PIC18(L)F24/25/45K50 Family Silicon Errata and Data Sheet Clarification

The PIC18(L)F24/25/45K50 family devices that you have received conform functionally to the current Device Data Sheet (DS30684A), except for the anomalies described in this document.

FIGURE 3-1: SIMPLIFIED OSCILLATOR SYSTEM BLOCK DIAGRAM

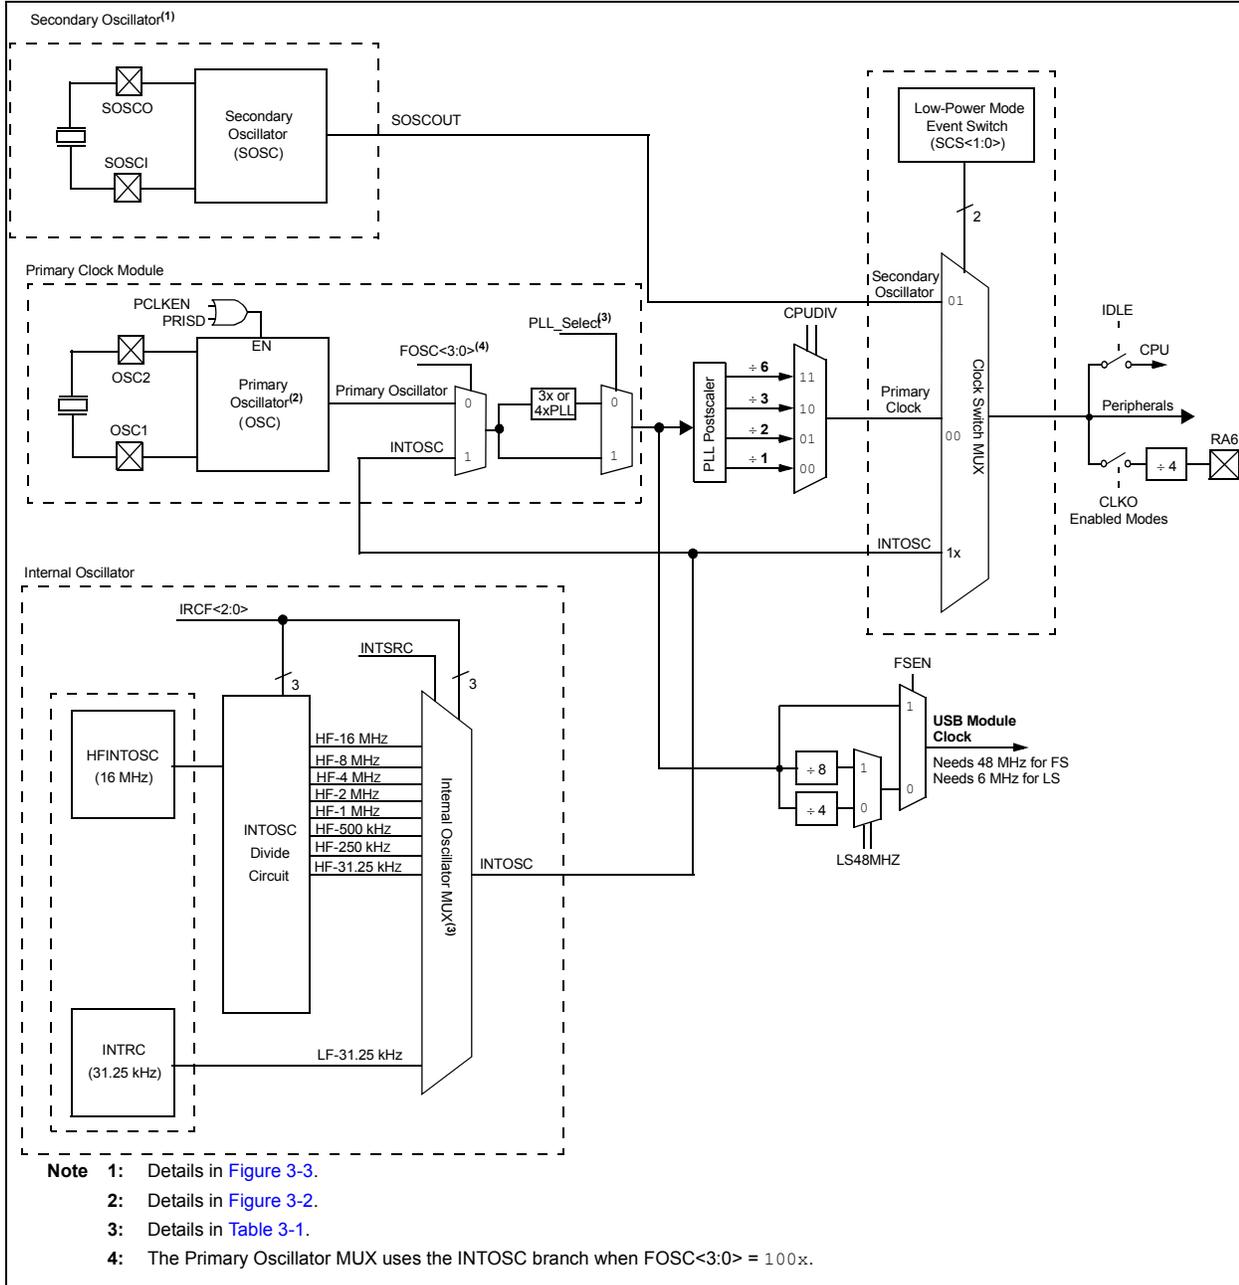
1. Module: CPU Divider

[Figure 3-1](#) from **Section 3.1 “Overview”**, as well as [Table 3-6](#) and [Table 3-7](#) from **Section 3.14.1 “Low-Speed Operation”** have incorrect data on the CPUDIV Configuration bits. The corrected versions are below:
